53 Elsworthy Road,
London NW3 3BS

Basement Impact Assessment
Audit

For
London Borough of Camden

Project Number: 12336-70

DETAILS OF ACROWS

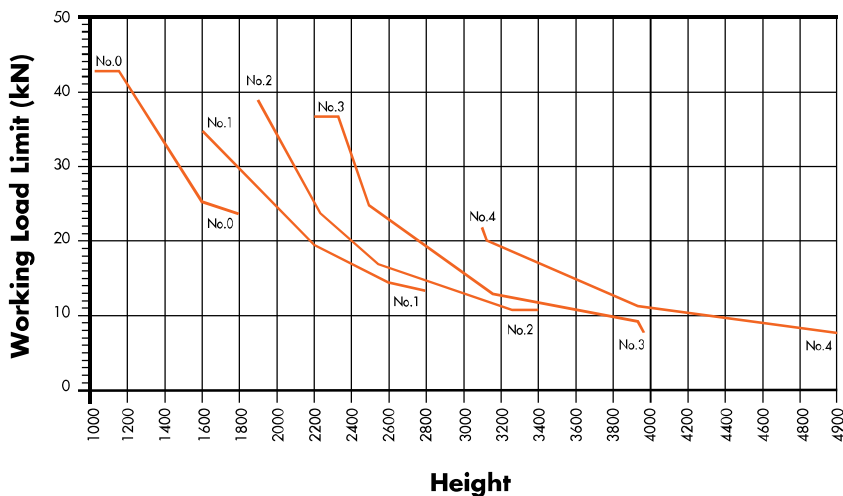
2. Indicative temporary works propping proposal.

A sequence of construction was provided with the original BIA and indicated props within the excavations to retain the subsoils. Calculations for these props have been requested and are provided below –

- From the calculations for the retaining wall contained in the BIA it can be seen that the maximum total horizontal force applied to the retaining wall is 78.7kN per metre.
- 3No pairs of props are indicated in each excavation. The excavations are a maximum of 1.0m wide.
- Design only the most heavily loaded pair of props at the base of the excavation.
- Conservatively assuming a purely triangular distribution of load, the bottom pair of props carry approximately 55% of the total load = 21.7kN per prop.
- For excavations where props will be up to 2m long, provide two No.2 acrows, capacity = 24kN each. See Appendix A for details.
- For excavations where props will be over 2m long, provide two No.6 Titan Super Props, capacity = 42kN each to 4.3m long. See Appendix B for details.
